**DEDICATED FREIGHT CORRIDOR CORPORATION OF INDIA LTD.  
5th Floor Pragati Maidan Metro Station Building, New Delhi-110001**

**Amendment/Corrigendum No.1 Dated: 02.12.2015**

**Bid Document No: HQ/EN/EC/SEB JN. Works dated 12.10.2015.**

<p>NAME OF WORK:- DESIGN AND CONSTRUCTION OF DFCC WORKS FROM SONNAGAR TO NEWSONNAGAR/BAGAHABISHNUPUR</p>	<p>TYPICAL CROSS SECTION OF ROAD</p>
---	--	--

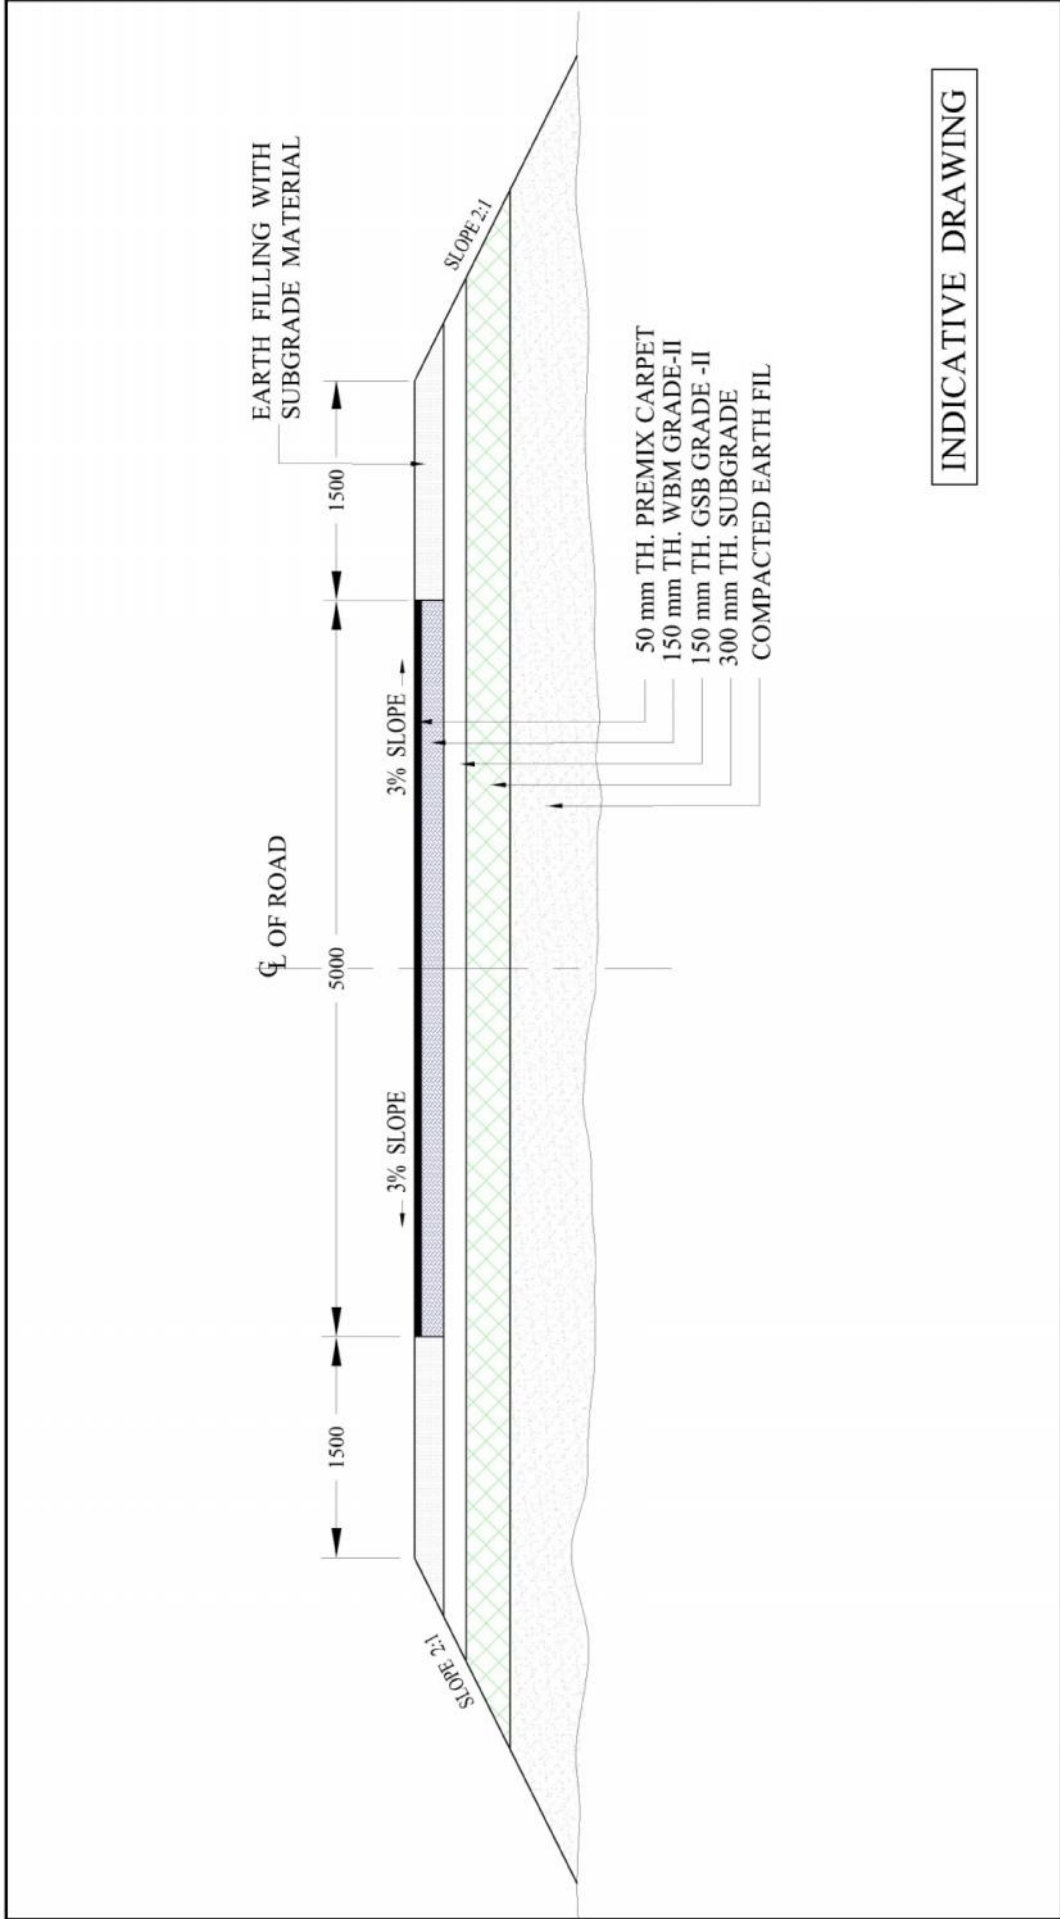
6.	Part-2, Section- V Volume-1	Para-2.0 (A) (j)  (Page No. 60 of 289)	<p><b>Delete the contents of existing sub-para 2.0 (A) (j) and replace with the following :</b></p> <p>“Station Building at New Sonnagar including <b>proper water supply arrangement, sanitary arrangement, septic tank, sewerage, drainage</b>, internal electrical wiring and related miscellaneous works <b>etc.</b> One borewell with the provision of submersible pump, rising, delivery pipe line connection to tank over building, <b>distribution pipe lines etc.</b> and one borewell equipped with hand pump should be provided to meet water requirements of station staff in all seasons.</p> <p><b>Electrical distribution line between Station Building and Quarters to be laid under the scope of this contract so that electric supply can be provided at single point near Station Building by DFCCIL. Electrical supply from state agencies up to single point near station building is not under the scope of work.</b></p> <p><b>Approach road to Station Building connecting with nearest road (i.e. diversion road as listed in chartered utilities Part-4 ‘Reference Documents’) has to be constructed as per indicative typical cross section of road given in Part-4 ‘Reference Documents’.”</b></p>

7.	Part-2, Section- V Volume-1	Para-2.0 (A) (k)  (Page No. 60 of 289)	<p><b>Delete the contents of existing sub-para 2.0(A) (k) and replace with the following :</b></p> <p>“Construction of quarters 8 units Type-II single storey approx. plinth area 55 Sqm. of each unit. at New Sonnagar including <b>proper water supply arrangement, sanitary arrangement, septic tank, sewerage, drainage</b>, internal electrical wiring and related miscellaneous works <b>etc.</b> For water supply arrangement, water tank of capacity 1000 litre to be provided over each unit should be connected with the submersible pump provided at station building including rising, delivery, <b>distribution pipe lines etc.</b> to meet water requirements of staff in all seasons.</p> <p><b>Electrical distribution line between Station Building and Quarters to be laid under the scope of this contract so that electric supply can be provided at single point near Station Building by DFCCIL. Electrical supply from state agencies up to single point near station building is not under the scope of work.</b></p> <p><b>Approach road to Quarters connecting with Station and nearest road (i.e. diversion road as listed in chartered utilities Part-4 ‘Reference Documents’) has to be constructed as per indicative typical cross section of road given in Part-4 ‘Reference Documents’.”</b></p>

<p>constructed with complete internal wiring, <b>water supply arrangement</b>, sanitary system, <b>septic tank</b>, <b>sewerage</b>, water pipelines, <b>drainage</b> etc.</p> <p><b>Electrical distribution line within the colony to be laid under the scope of this contract</b> and to be connected with electrical connection point given/shown by employer <b>within 1 Km</b>. Location of quarters will be at Sonnagar or between Mughalsarai-Sonnagar as approved by the Engineer.</p> <p><b>Colony roads and approach road to Quarters shall be constructed as per indicative typical cross section of road given in Part-4 'Reference Documents' and connected with nearest existing road."</b></p>

Reference Documents	(iii) Details of ROB (Page 284 of 289)	
25.	Part-4 Reference Documents	Para (2) (i) Civil Utilities, S.No. 2, (Page 287 of 289)	In the Column 'Name of Structure' at S.No.2 shall be read as under :  "Re-location of existing Road approx. <b>430 metre</b> length as per <b>indicative Typical Cross Section of Road provided in Part-4 'Reference Documents'.</b> "
